PROJECT SCOPING PLAN FOR PERFORMING A CERCLA
REMEDIAL INVESTIGATION/FEASIBILITY STUDY (RI/FS) AT
THE FILL AREA WEST OF BUILDING 135 (SEAD-59), AND THE
ALLEGED PAINT DISPOSAL AREA (SEAD-71), SENECA ARMY
DEPOT ACTIVITY

APRIL 1997

**PROJECT SCOPING PLAN
REMEDIAL INVESTIGATION/FEASIBILITY STUDY
AT SEAD-59 and SEAD-71
SENECA ARMY DEPOT ACTIVITY
ROMULUS, NEW YORK**

**FIGURE 3-15
 GROUNDWATER ELEVATION MAP**

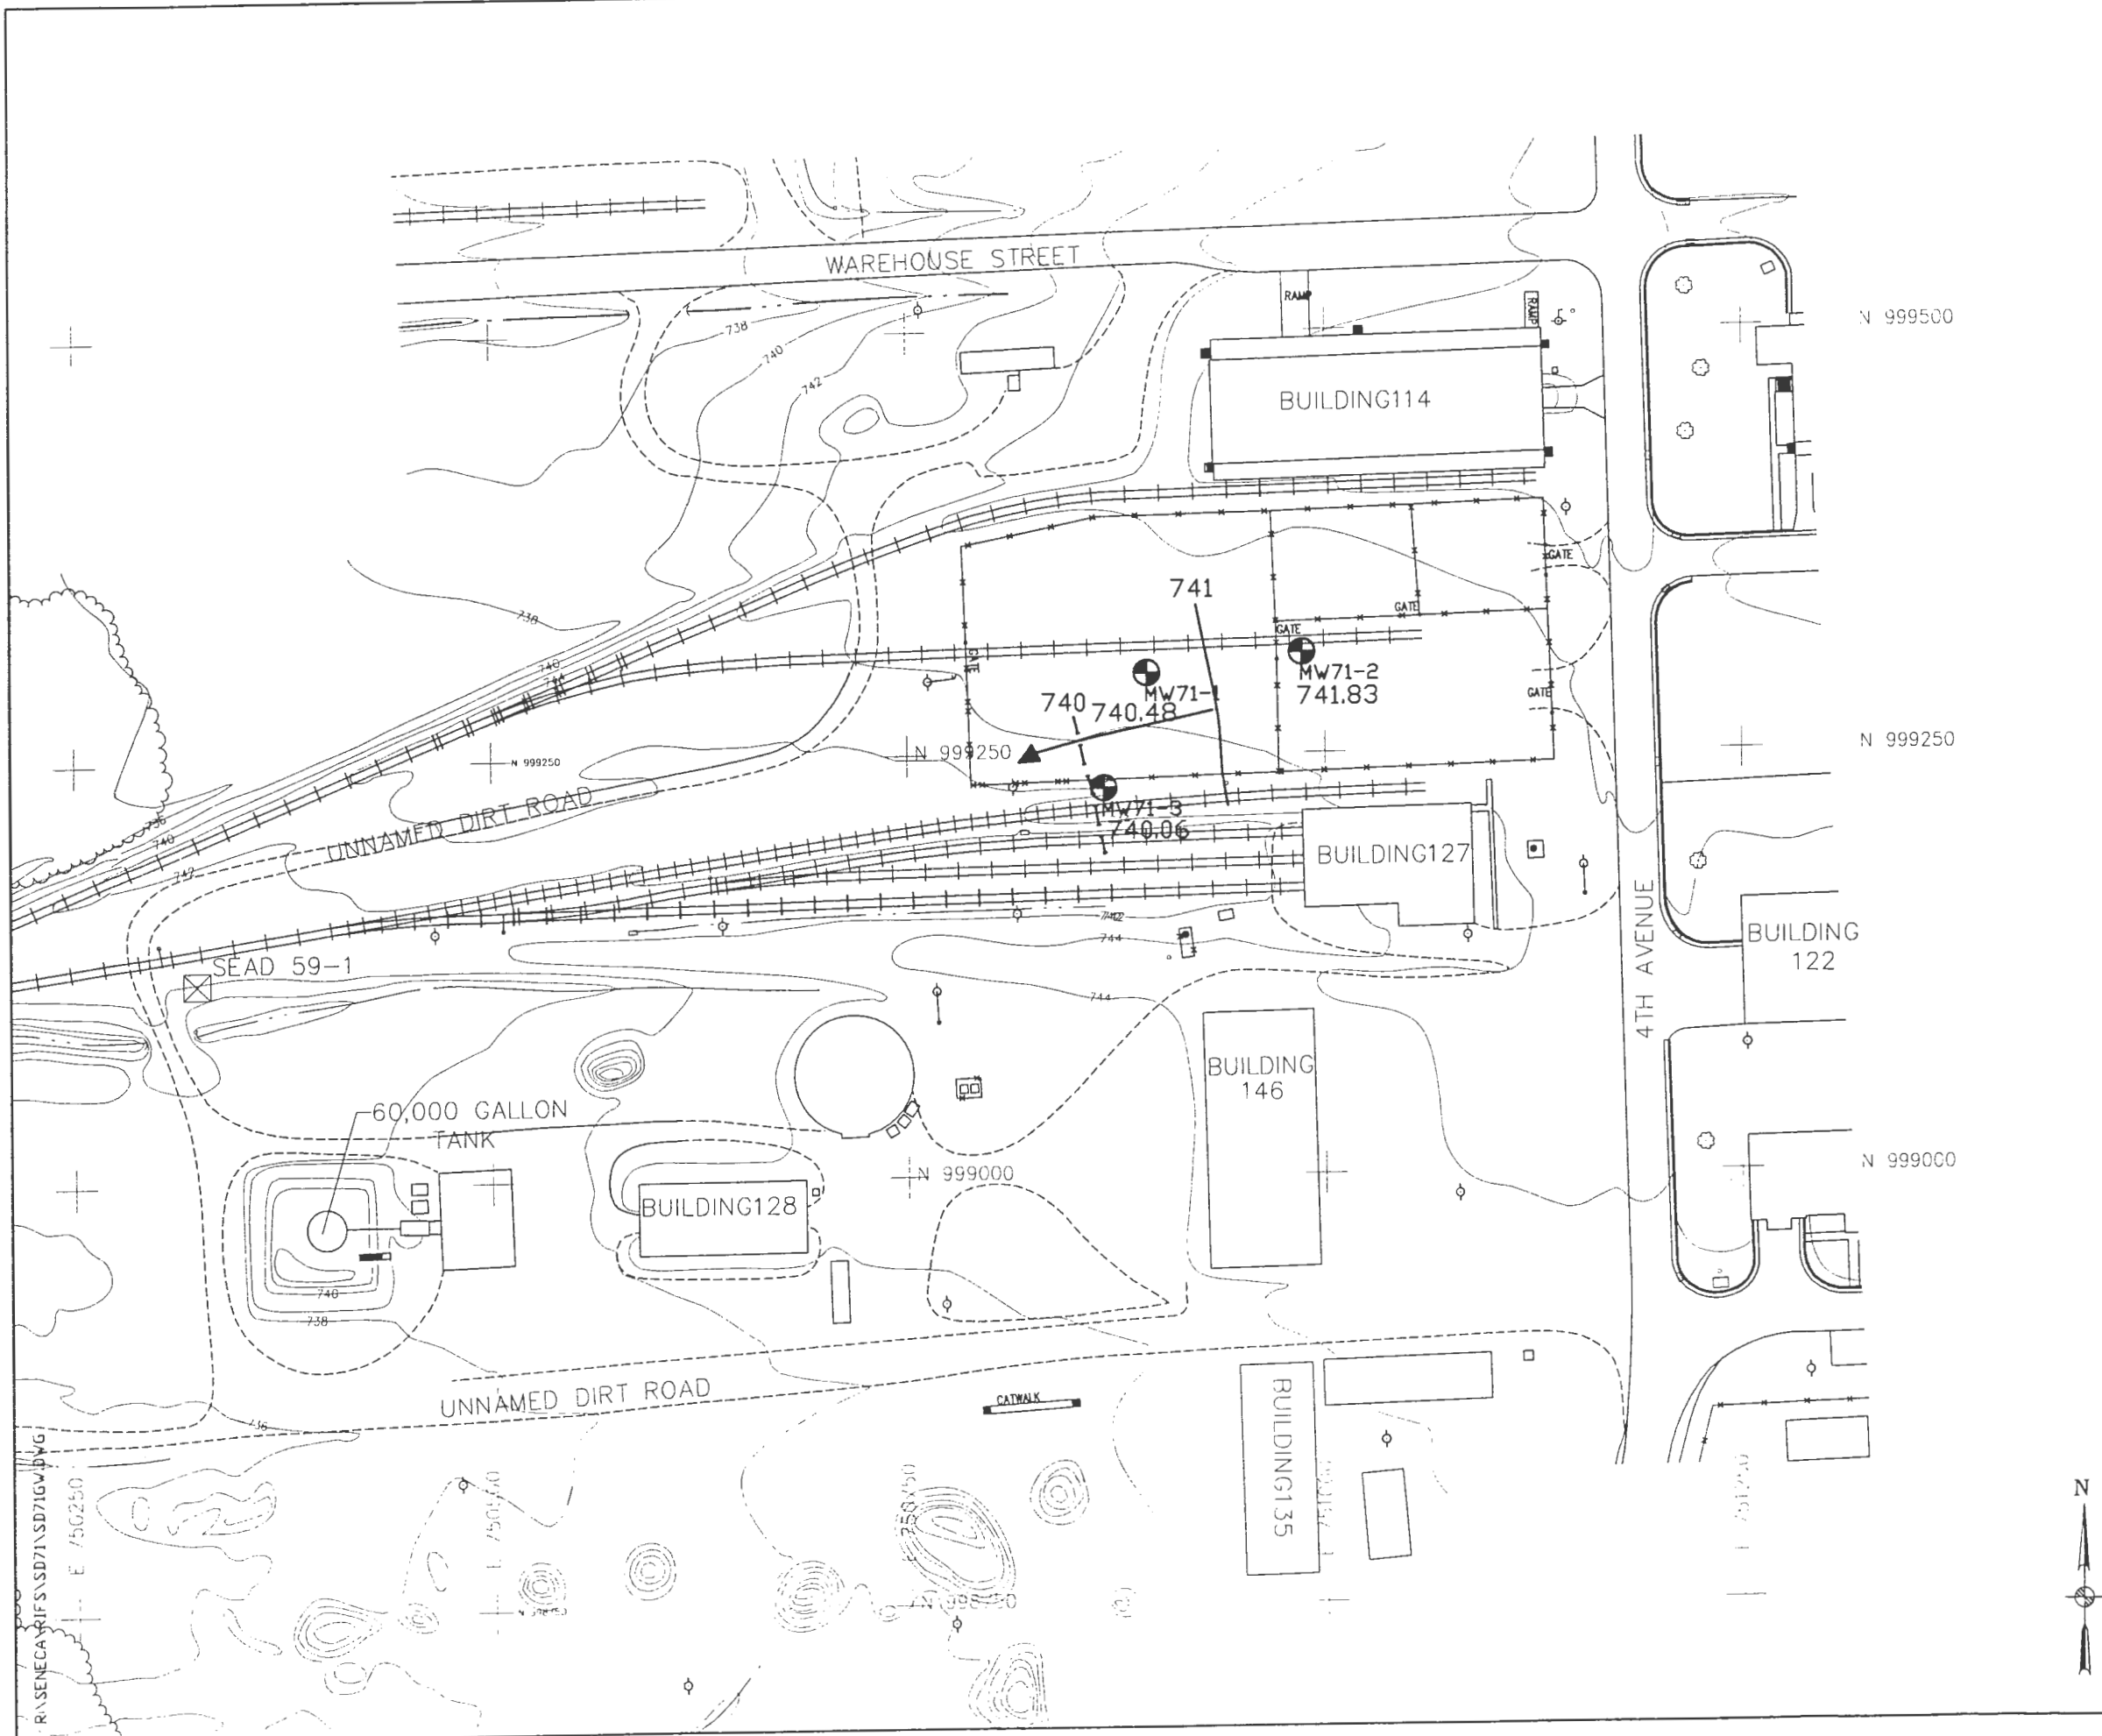
- Response #5** Agreed. The text in Section 3.1.1.2.5 of the Scoping Plan has been revised as recommended in the comment.
- Comment #6** Figure 3-19: It is unclear what control was used to construct the 740 foot contour line presented on this figure.

FIGURE 3-16
TOTAL PAHs IN SUBSURFACE SOILS

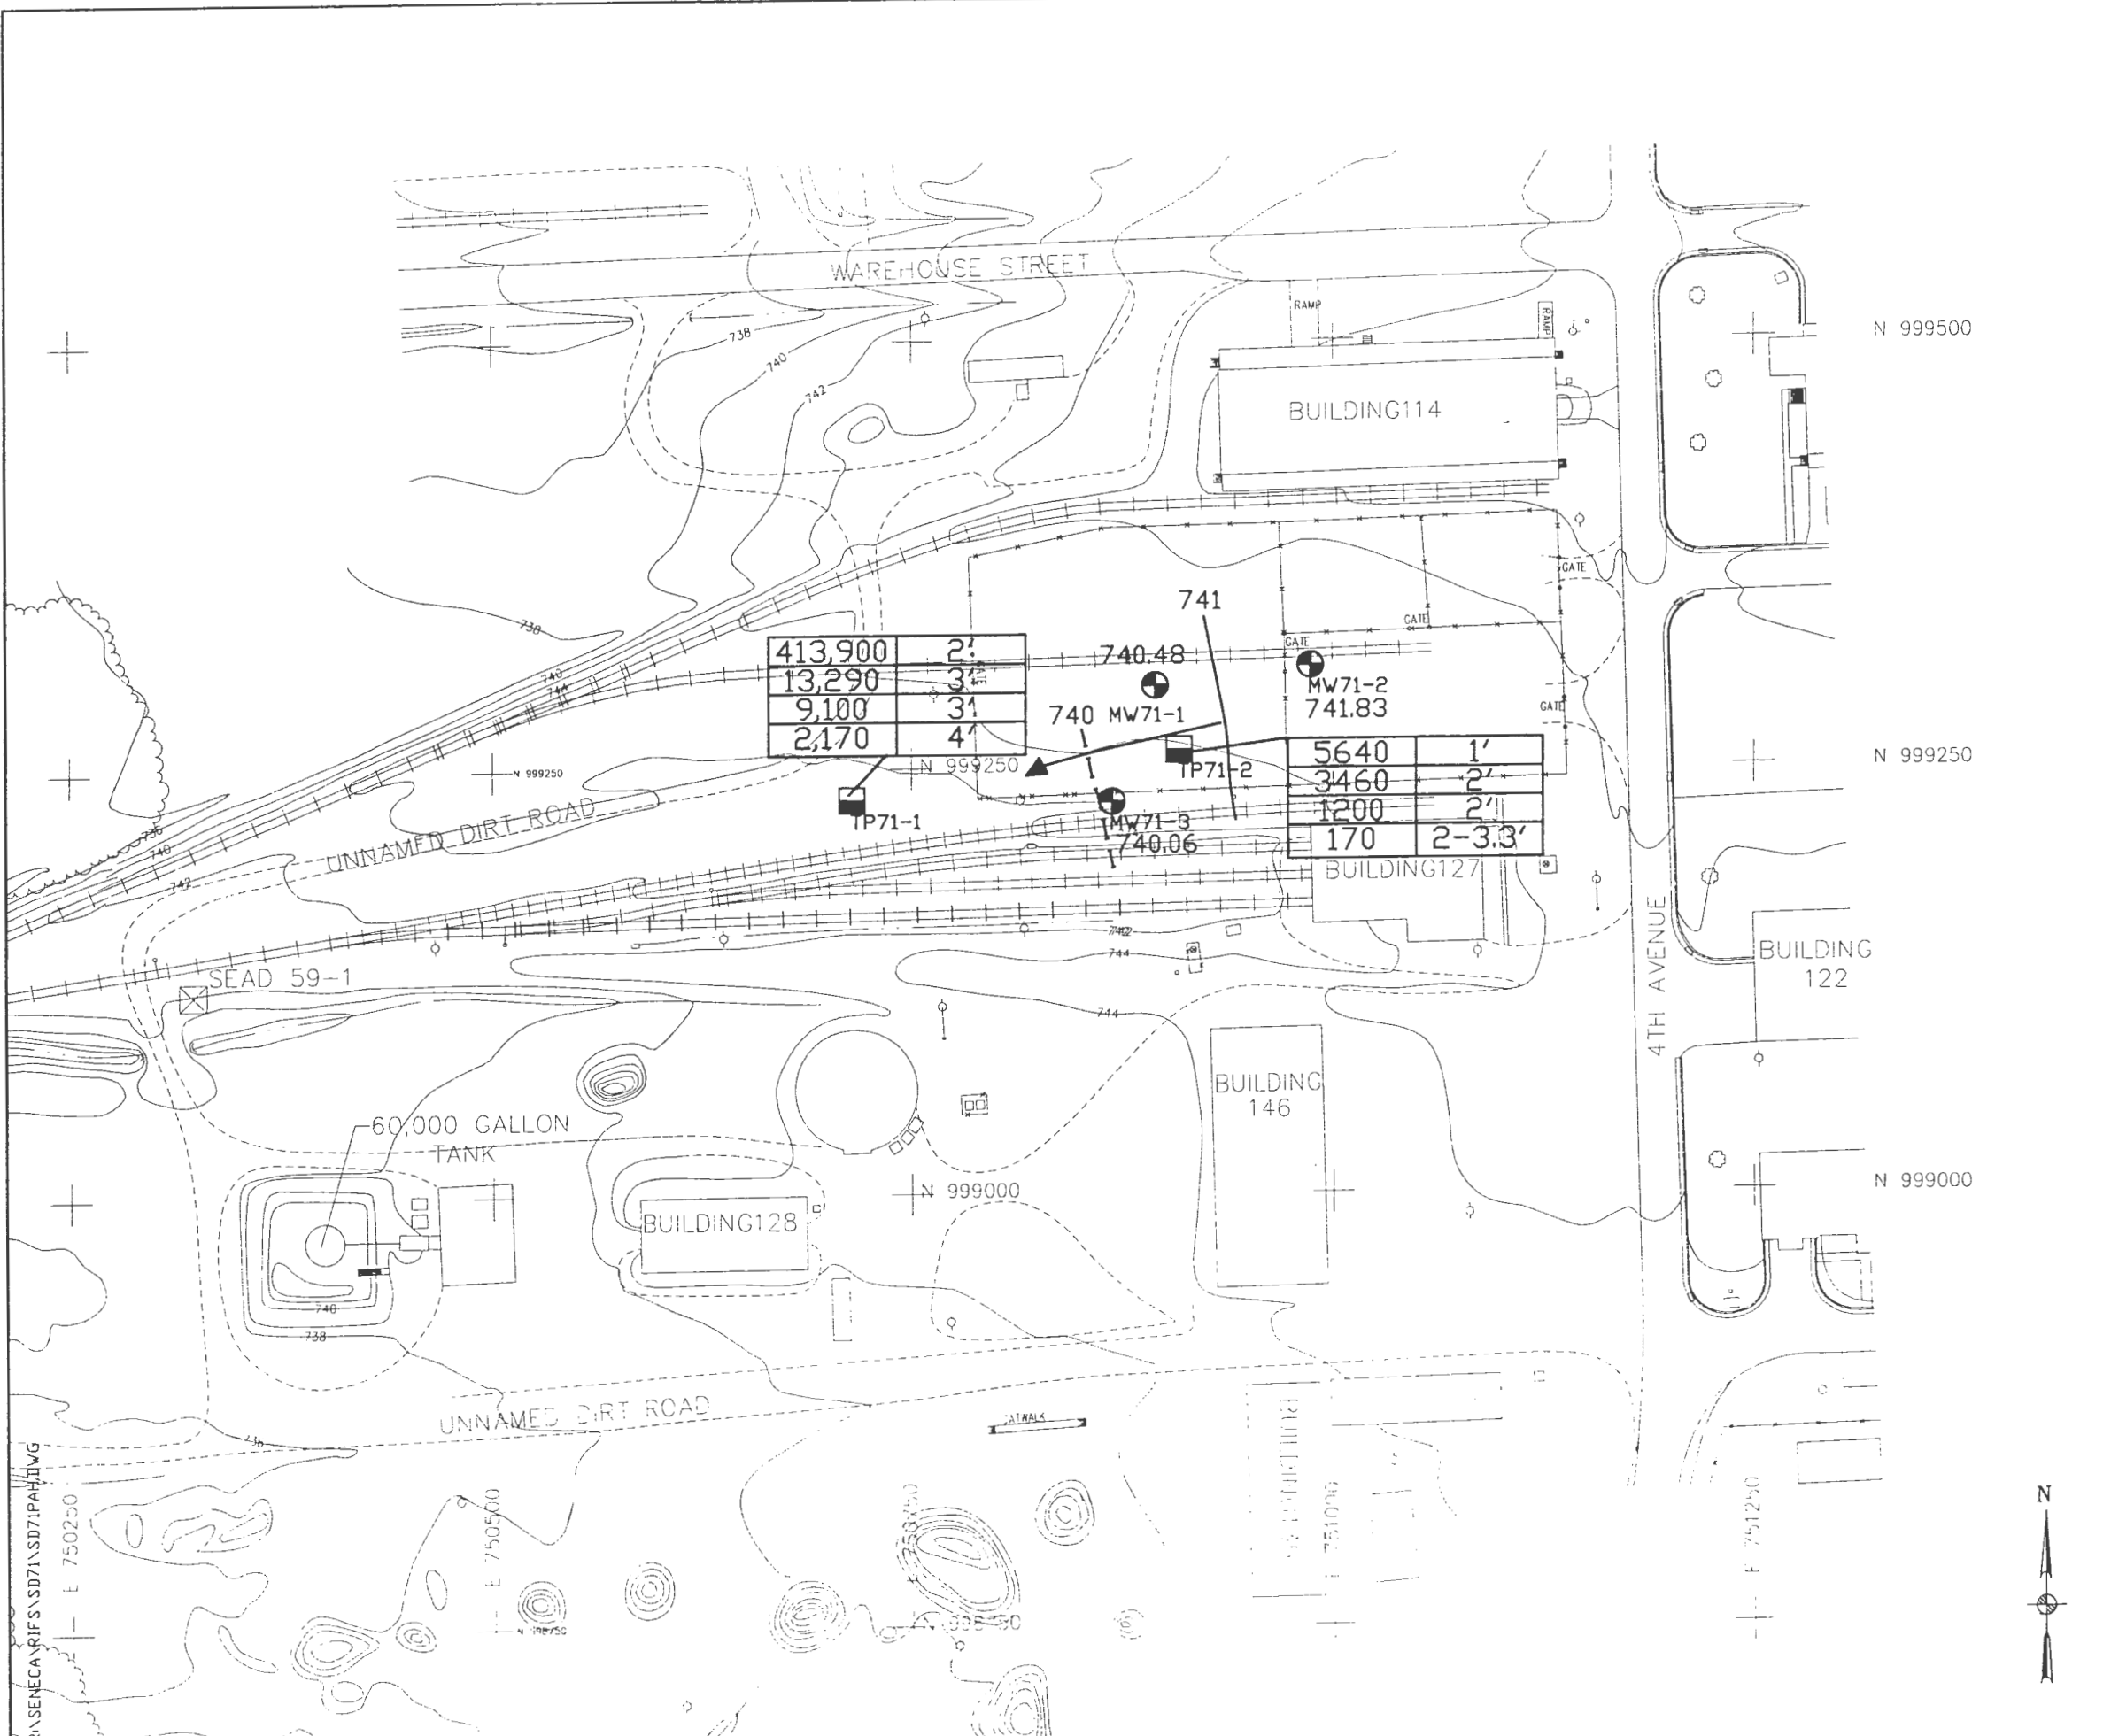
- Comment #7** Figure 3-20: See comment for Figure 3-19. The construction of the groundwater contours in Figure 3-20 is not consistent with Figure 3-19. In general, even though the contour lines are dashed on Figure 3-20 to indicate that they are inferred, they extend well beyond any control points.

- Response #7** Agreed. The groundwater contours in Figure 3-16 (formerly 3-20) have been revised so that they are the same as those shown in Figure 3-15 (formerly Figure 3-19).
